PUBLIC IMPROVEMENT REQUEST FOR PROPOSAL

RFP# 26-11

N. University & Thayer Improvements

ADDENDUM No. 2

SHEET No. 22 OF 80

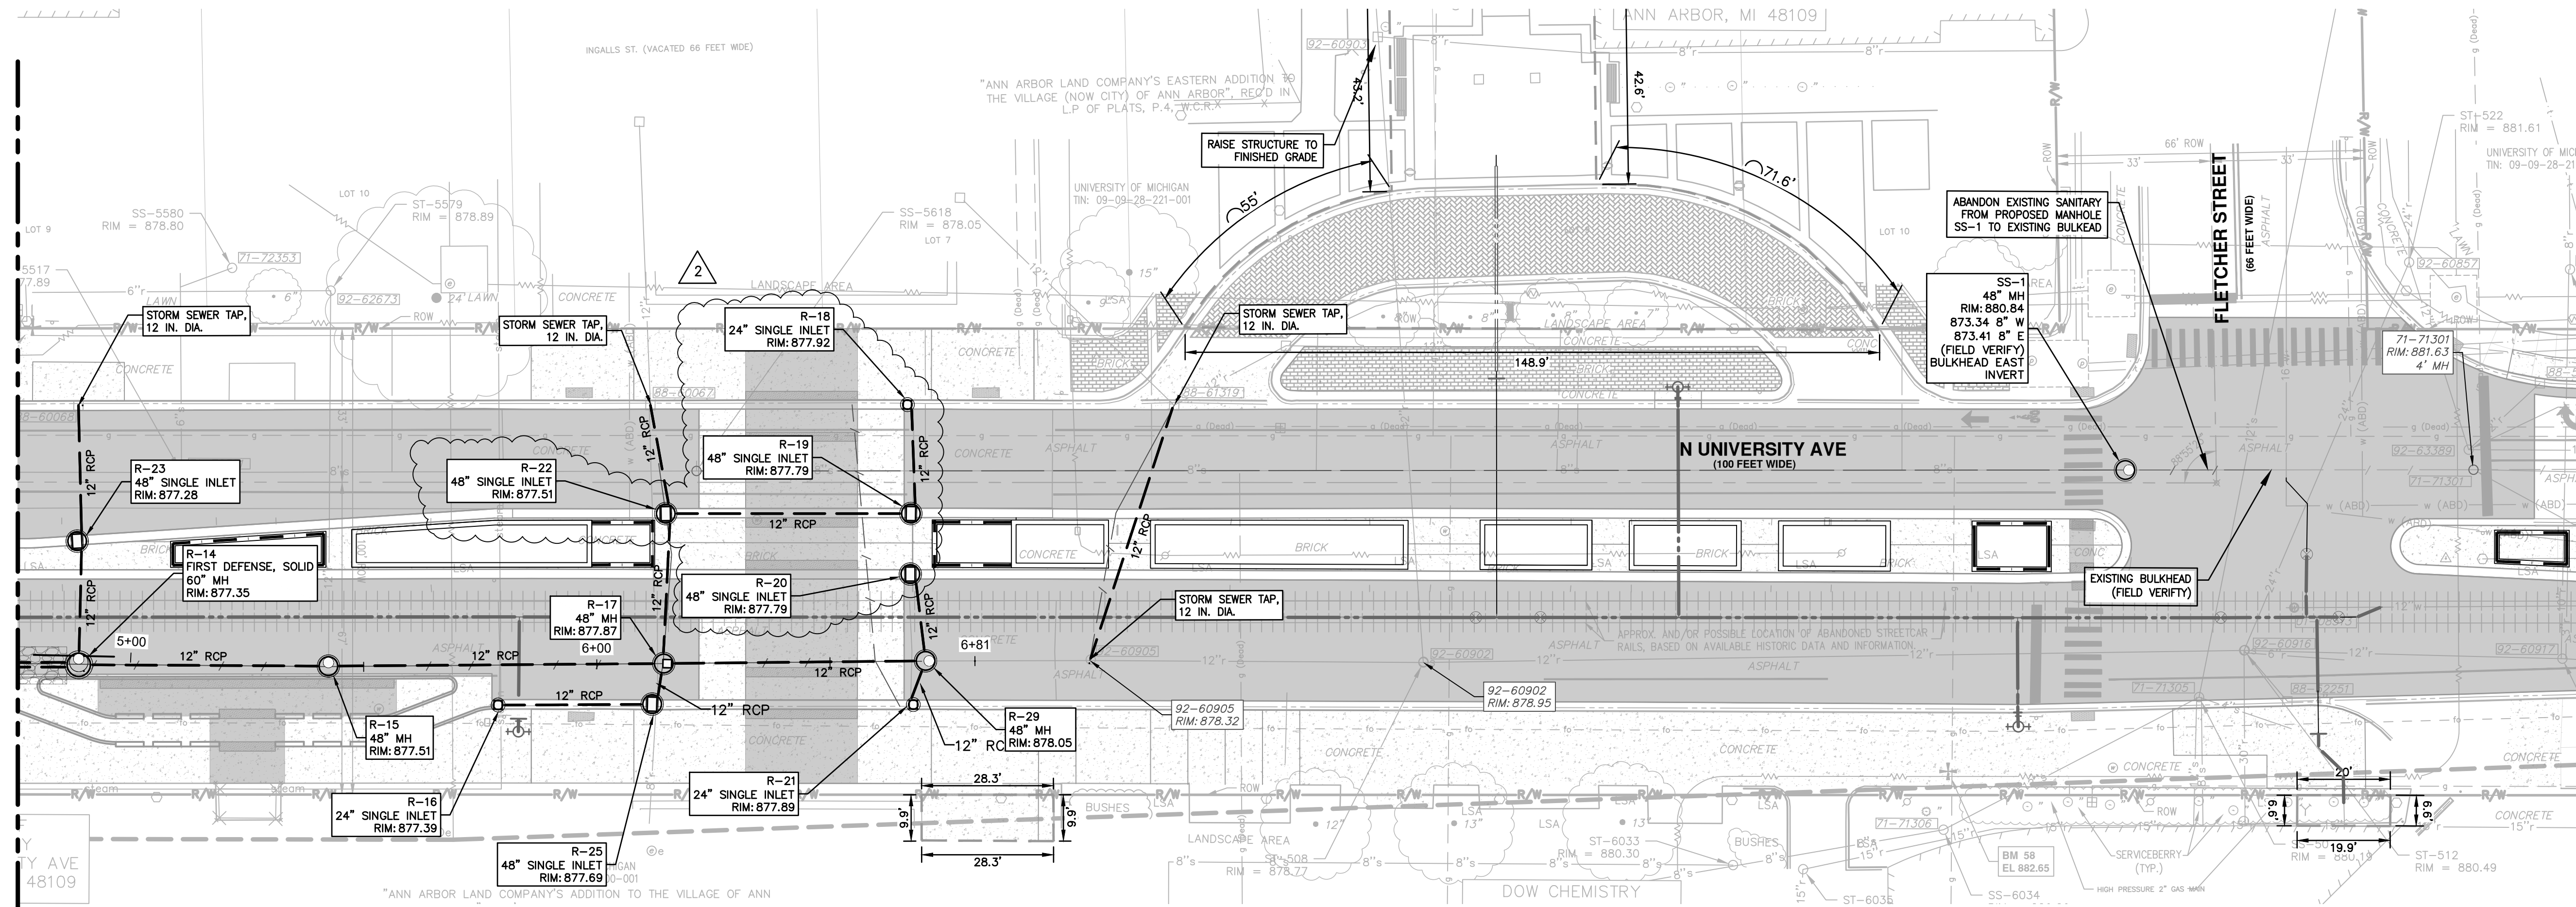
Plan Sheet 22	Note for aggregate base for utility trench has been revised from Aggregate Base, 15 in, to 21AA to Aggregate Base, 17 in, 21AA.
Plan Sheet 40	Storm sewer alignment revised between Structure R-19 to R-20, and R-19 to R-22.
Plan Sheets 42-43	Plan and profile updated to reflect changes between Structure R-19 to R-20, and R-19 to R-22. The rim elevation for structure R-6 was also updated.
Plan Sheets 44-48	“CONC, SIDEWALK, DRIVE APPROACH, OR RAMP, 6 IN., HIGH EARLY” & “CONC, SIDEWALK, DRIVE APPROACH, OR RAMP, 8 IN., HIGH EARLY” added to construction key. Drive entrances modified to reflect utilization of high early concrete and quantities revised to reflect these changes.
Plan Sheet 49	Updated to reflect revised light pole locations.
Plan Sheet 52-54	Updated to reflect revised light pole locations. The valve box rim elevation was also revised.
Plan Sheet 64-66	Light pole location and conduit alignment revised.

Question 28: On sheet 22, for the cross section of the pre-art fair phase on Thayer St, it shows 15" 21AA aggregate base to be placed within the trench areas. How is this aggregate base paid for? There is no current item in the bid item list.

Answer 28: The pay item was changed to 17" 21AA aggregate base.

SCALE: 1"=20'
 DRAWING No. 2023-023-69

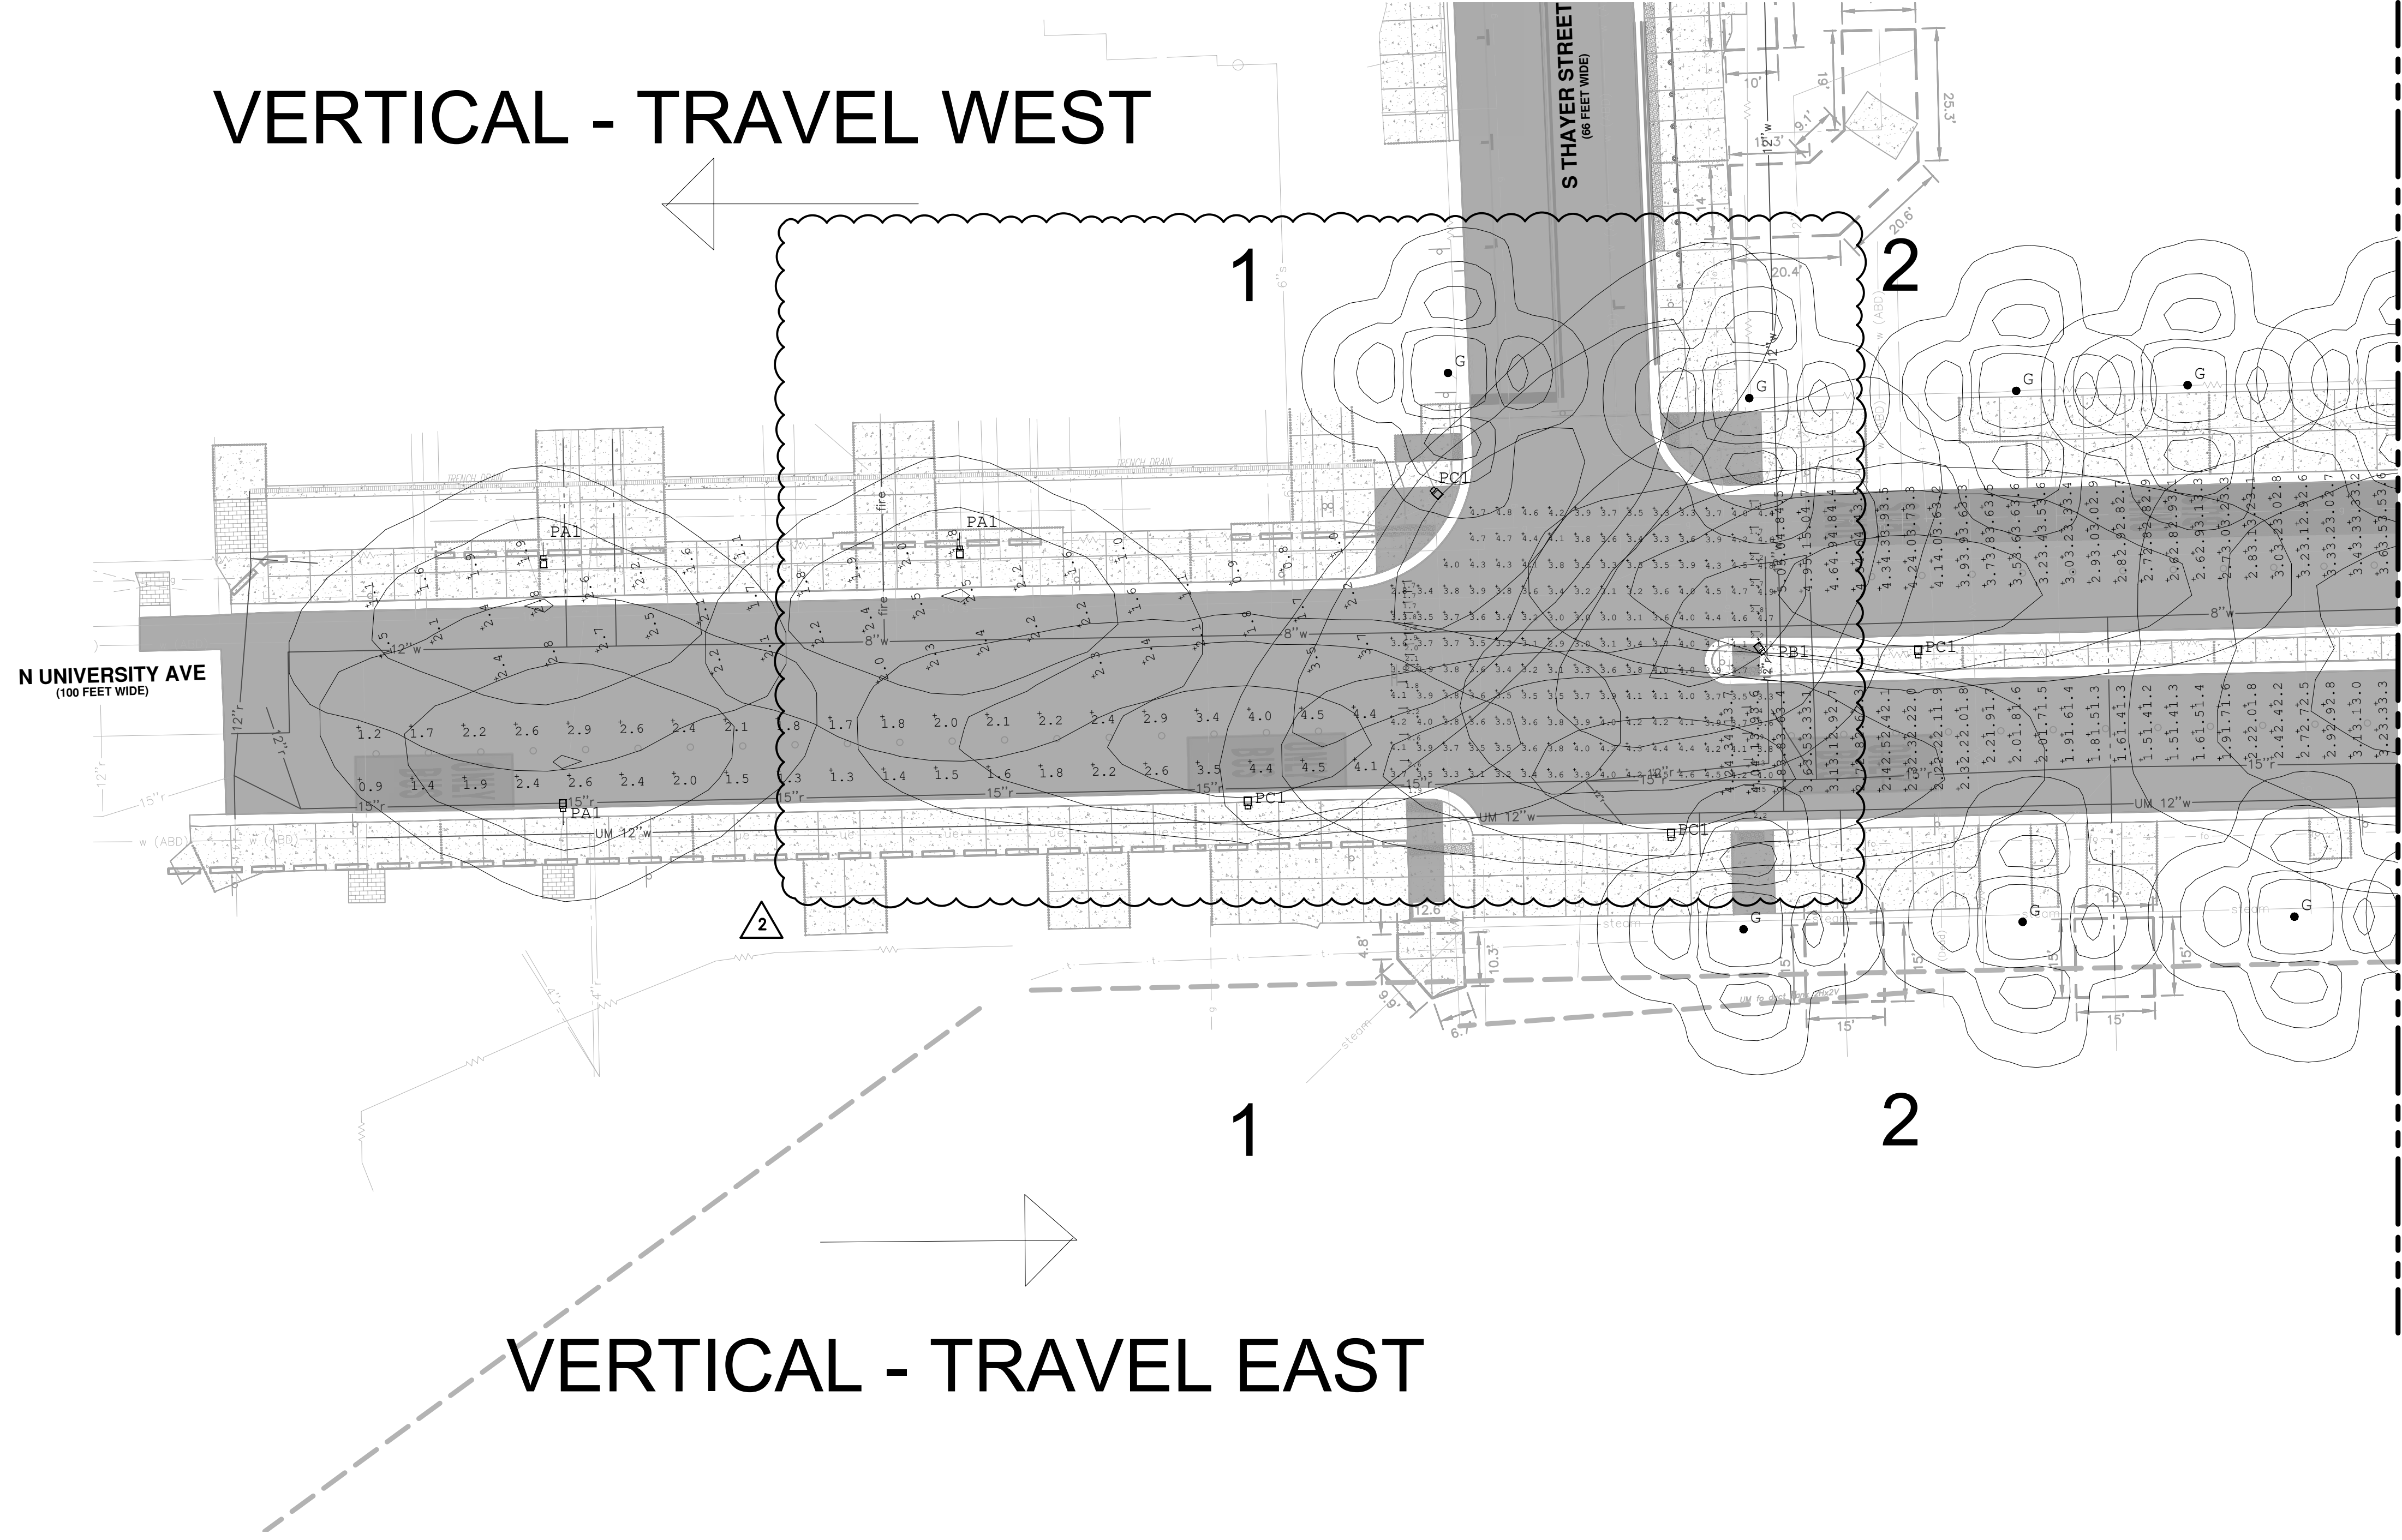
Plan Sheet 67	Luminaire schedule and fixture wattage and distribution revised.
Plan Sheet 69-70	Lighting calculation summary and luminaire schedule updated to reflect revised light pole locations and fixtures. The photometric plan was updated to reflect revised light pole locations and fixtures.
Sewer Inspection Report	Reports for sewer inspection for storm and sanitary in the project limits has been added as part of this addendum. See Question 12 in Section II.

CITY OF ANN ARBOR - ENGINEERING
N. UNIVERSITY & THAYER IMPROVEMENTS
PROPOSED WATER MAIN - NORTH UNIVERSITY STA 3+50 TO STA 7+50

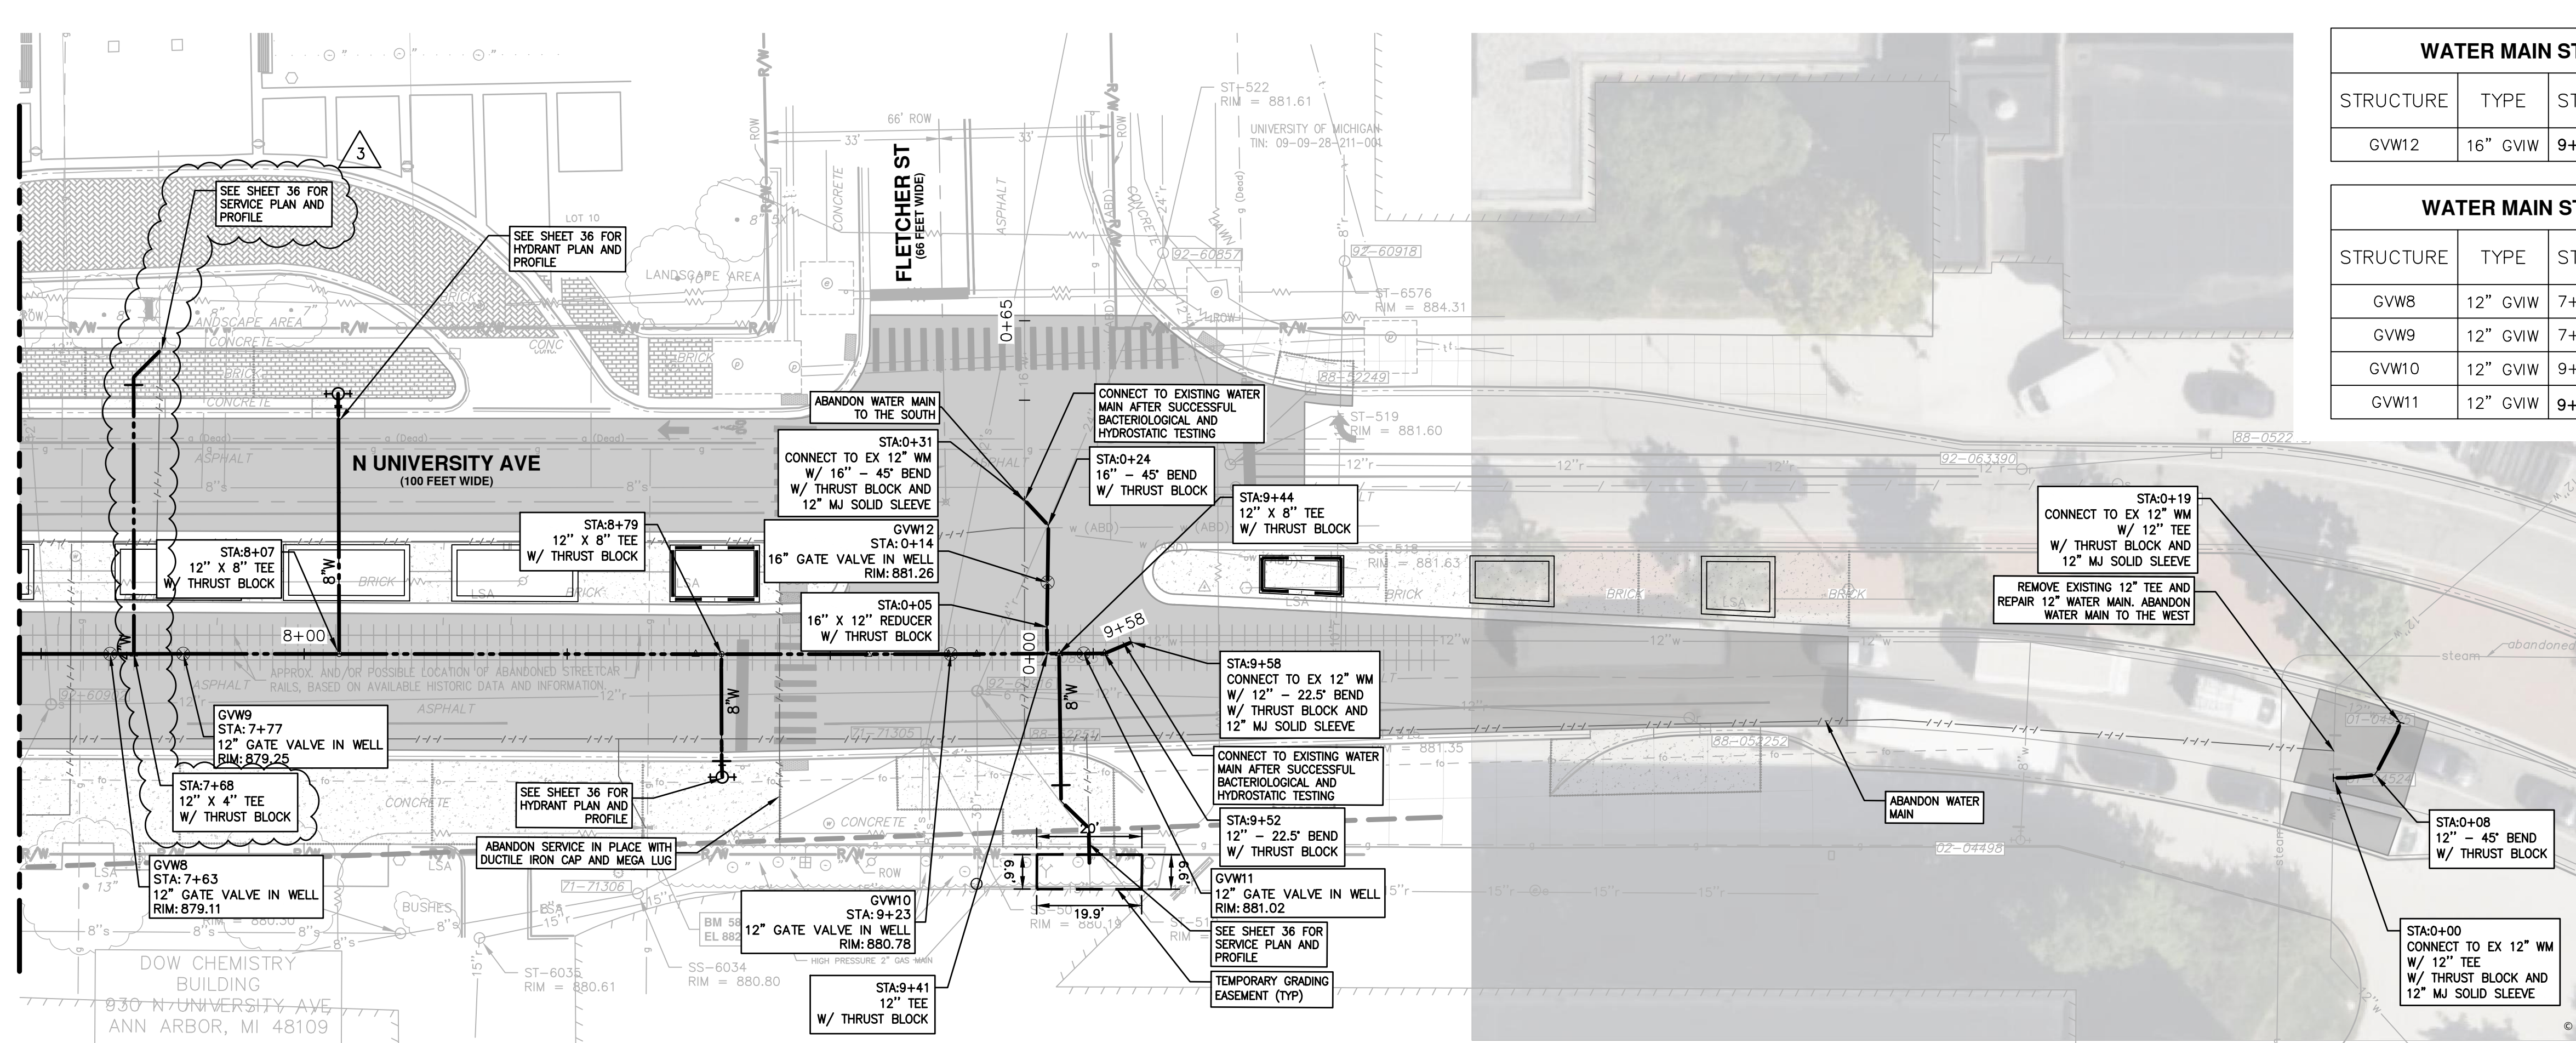
Plan Sheet 29	Revisions made to water service lead to Michigan League building.
Plan Sheet 32	Revision of layout of proposed planter boxes in the North University median.
Plan Sheet 33	Revisions made to water service lead to Michigan League building.
Plan Sheets 35	Revision of layout of proposed planter boxes in the North University median.
Plan Sheet 36	Revisions made to water service lead to Michigan League building.
Plan Sheets 40	Revision of layout of proposed planter boxes.
Plan Sheet 42	Revision of layout of proposed planter boxes.
Plan Sheet 45	Revision of layout of proposed planter boxes. Quantities have been updated as a result.
Plan Sheet 46	Revisions made to water service lead to Michigan League building.
Plan Sheet 52-53	Revision of layout of proposed planter boxes.
Plan Sheet 57	Revision of layout of proposed planter boxes.
Plan Sheet 65	Revision of layout of proposed planter boxes.
Plan Sheet 71	Revision of layout of proposed planter boxes.
